Report to Sydney Central City Planning Panel

SCCPP reference	PPSSCC-413
DA No.	1001/2022
Date of receipt	21 December 2022
Proposal	Demolition of existing buildings and structures, tree removal and remediation works and construction of a temporary club house and associated temporary car parking spaces. Construction of seven (7) buildings (3 to 8 storeys) containing 155 independent living units for the purposes of seniors housing (including people with a disability); construction and operation of a new registered club (Oatlands Golf Club); and 405 car parking spaces over 2 basement levels (200 club and 205 residential spaces); and landscaping and ancillary facilities. Torrens title subdivision into 2 lots (to separate the site from the golf course land) and further, subdivision of one of the subject lot into 17 lots in a community scheme and strata subdivision of the independent living units.
Street address	94 Bettington Road, Oatlands
Property Description	Lot 100, Deposited Plan 1243044

Recommendation	Refusal
Report by	Bianca Lewis, Executive Planner

Figure 11: View looking south corner Bettington Road and Pennant Hills Road (Source Council's Visual Analysis, February 2023)

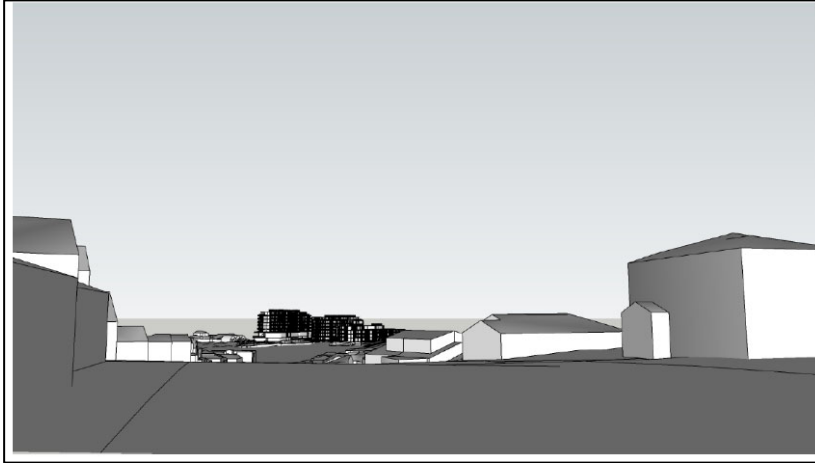
Figure 11 shows the view south on the corner of Pennant Hills Road and Bettington Road. This highlights the proposed development's prominence in the wider context and inconsistency with the typical built form of its surrounds. As detailed in Section 9 - Parramatta DCP this is a significant view within the local government area.

Buildings B and C (7 and 8 storeys respectively) do not provide an acceptable built form relationship with, or respond to the neighbourhood character of, existing 1 to 2 storey residential areas nor with the adjacent Oatlands House. Visibility is from Niblick Crescent to the south (refer Figure 13), around the golf course and surrounding residents along Bettington Road from the west and north (refer Figure 12). The building bulk is overwhelming to the natural landscape character of the golf course which has largely preserved its landscape setting.

Based on the above context analysis, it is recommended that Buildings B and C are reduced to no higher than 4 storeys in this location to minimise visual impacts and provide an acceptable and responsive built form to the context.

Figure 16 & 17: View facing south east to the southern boundary of the development site to adjoining properties at Niblick Crescent (Authors photo January 2023)

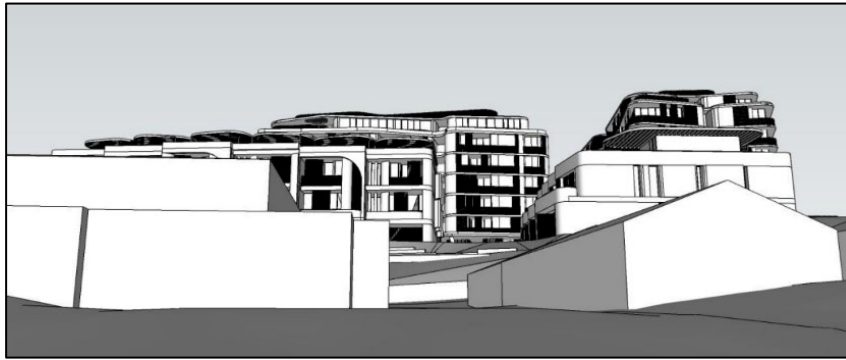
The townhouses located on the southern boundary of the development site are located adjacent to the rear of properties along Niblick Crescent. Recent photographs (Figures 16 and 17) show the difference in levels between the subject site and adjoining properties.

The proposed levels and grading to the internal laneway and rear of townhouses has resulted in a large retaining wall interface to the rear of the houses along Niblick Street which interferes with the natural landform. Furthermore townhouses TH04 to TH09 have first floor balconies facing directly south. It is unclear from the plans and sections provided what potential impact this would have in terms of overlooking to adjoining properties.

Based on this context analysis it is recommended that the townhouses be no more than 2 storeys in order to create an acceptable built form relationship and reduce impacts to neighbouring properties. Townhouses should be stepped with the natural topography to ensure they respond to the site conditions and reduce building bulk.

Figure 18: View looking north from Niblick Crescent (25 and 23 Niblick Cr in foreground) (Source Council's Visual Analysis, February 2023)

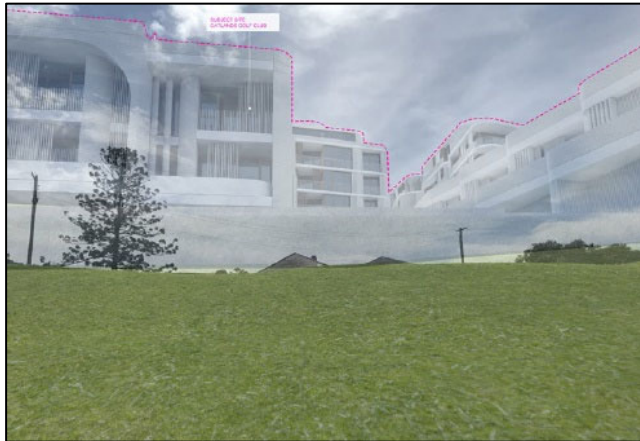
The proposed development causes additional overshadowing on adjoining private open space of 21, 23 and 25 Niblick Crescent and 92 Bettington Road, this is detailed in Section 7.3 of this report. The overshadowing impact to the child care outdoor play space at 92 Bettington Road is not compliant with the DCP and Child Care Planning Guidelines requirements.

Figure 21 : Ground Level Landscape Plan 09, southern communal area (Sturt Noble Nov 2022)

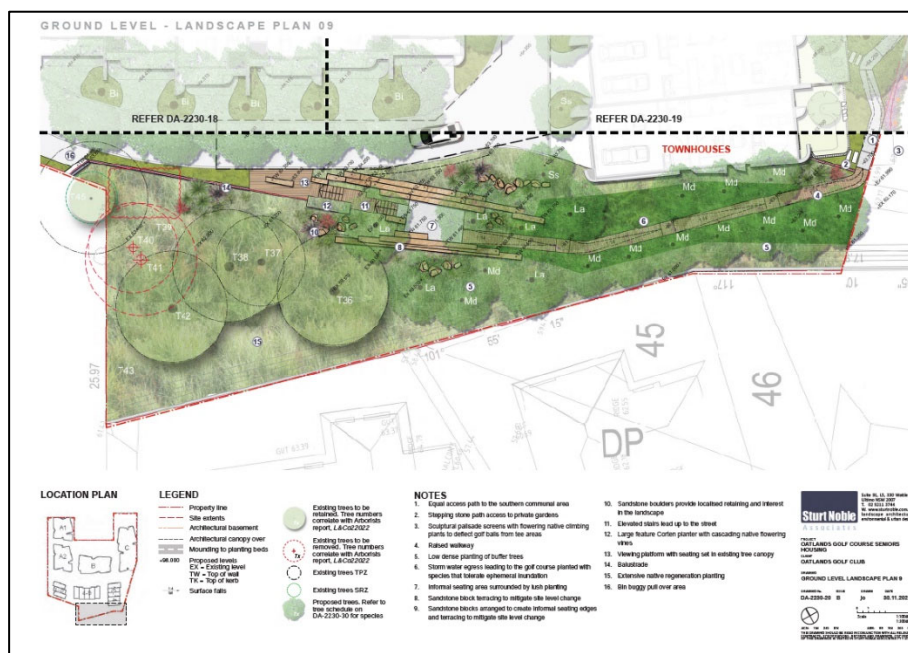
The proposed communal open space located at the southern portion of the development will have the potential for overlooking and privacy impacts on the private open space on properties adjoining on Niblick Crescent (Refer Figure 21).

Figure 23 – Approved ground floor plans (DA/491/2006) child care centre, 92 Bettington Road

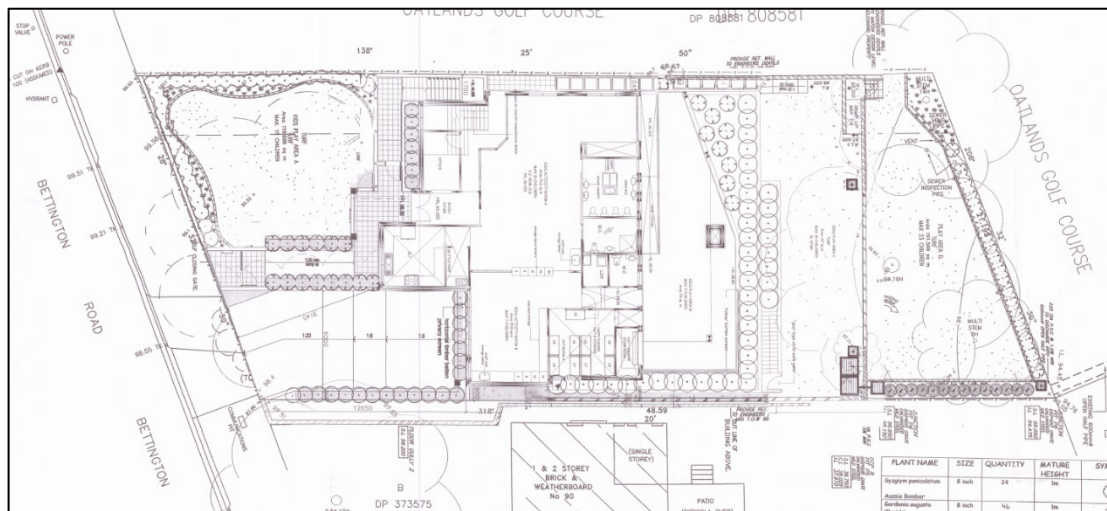
Under the proposed development, the rear play space receives solar access to 30% or more of its area between 10am and 1pm. Between 9am and 10am, and 2pm and 3pm less than 30% of solar access is achieved to its area. Therefore, the Child Care Planning Guideline standard is not met.

Under the proposed development, the total outdoor area receives solar access to 30% or more of its area between 10am and 2pm (4 hours). Between 9am and 10am, and 2pm and 3pm (2 hours) less than 30% of solar access is achieved to its area. Therefore, the Child Care Planning Guideline standard is not met.
